# **Update on Magnet Circuits Configuration**

TCC July 7 2016

# Conceptual Design Review of the Magnet Circuits for the HL-LHC: - 21-23 March, 2016 - **Review Report**

## HL – LHC Engineering Change Request CHANGES IN CIRCUIT BASELINE AFTER THE CONCEPTUAL REVIEW HELD IN MARCH 2016

# Outcome of June 2016 «crises exercise»

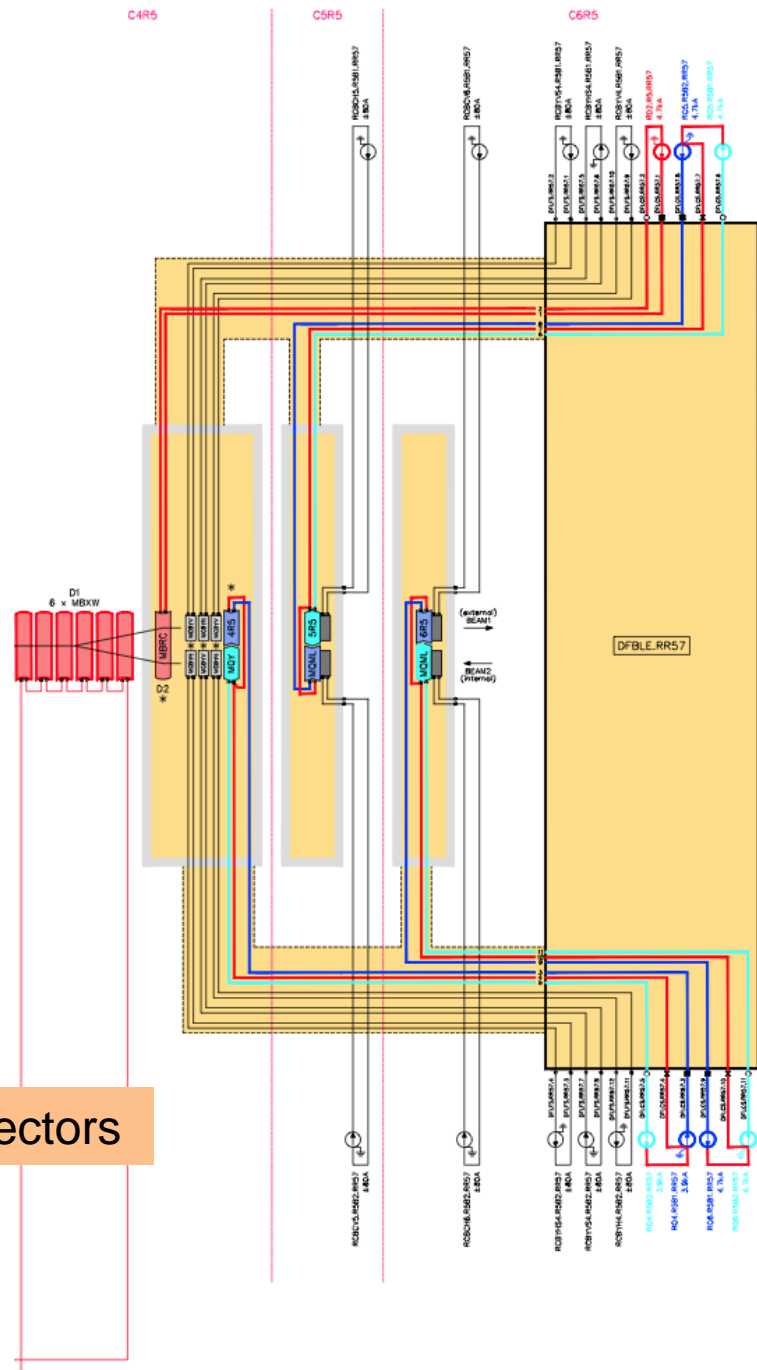
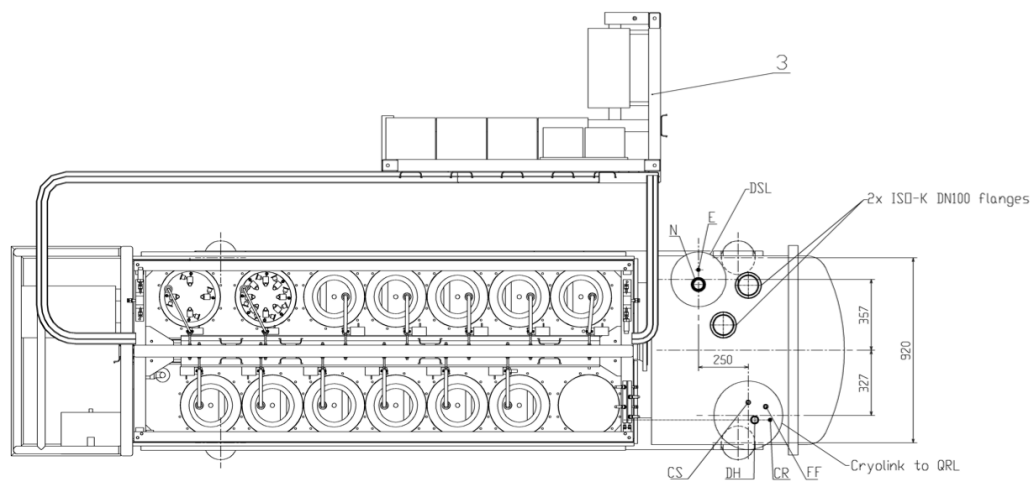
- Staging installation of new MQYY as new Q4 (90 mm aperture) to after HL-LHC end (i.e in LS4), *if needed*, maintaining present 70 mm MQY, i.e. Q4 modified for 1.9 K operation.
- QPS for the MQXF maintaining all systems ( $QH_{out}$ ,  $Qh_{inn}$ , ( $Qh_{intr}$ ), and CLIQ) however with a minimal configuration **with redundancy**.
  - Integration of CLIQ in LHC UL
- Powering the IPQs (Q6-Q5-Q4) from the RR, via existing EPCs, DFBLs (and links?)...

Q6 remains as is in LHC now  
 Q5 will be the present Q4  
 Q4 will be an MQY @ 1.9 K + 4 correctors/beam
